Docket No. 217 - Development and Management Plan Inspection

Northeast Utilities Service Company Certificate of Environmental Compatibility and Public Need for the construction of a 345-kV electric transmission line and reconstruction of an existing 115-kV electric transmission line between Connecticut Light and Power Company's Plumtree Substation in Bethel, through the towns of Redding, Weston, and Wilton, and to the Norwalk Substation in Norwalk, Connecticut.

Date:	September 13, 2006
-------	--------------------

Location: Norwalk Substation Expansion

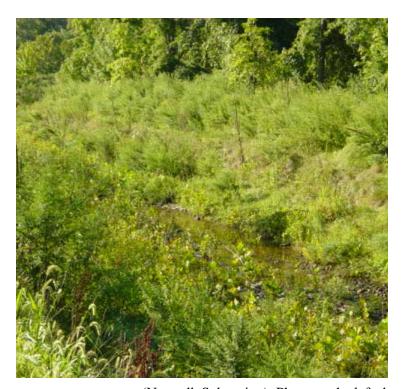
Areas of Inspection	Observation	Recommended Action	Corrected Action
	equipment. 9/13/06. -Sediment had been noted in the wetland swales adjacent to the access road. 7/5-9/13/06	- This is likely a pre- existing condition and not directly related to the expansion work. However, if the road can be further stabilized, this may help the situation. 7/19-9/13/06	- Needs evaluation
Foundation construction	- Most major site work is complete. Remaining activities involve electrical testing and switching. 9/13/06.	- Remain aware that the perimeter of the yard is surrounded by wetlands. See erosion control section. 3/15-9/13/06.	-N/A at this time.
Erosion and Sediment Controls (includes inspection within 24 hours of a storm event)	- The site has been graded on an even level to the perimeter stone berm towards the rear of the site. 7/19-9/13/06	- The berm must remain maintained as sediment control. It may need to be built up with stone in order to filter effectively. 7/19-9/13/06	- Needs evaluation
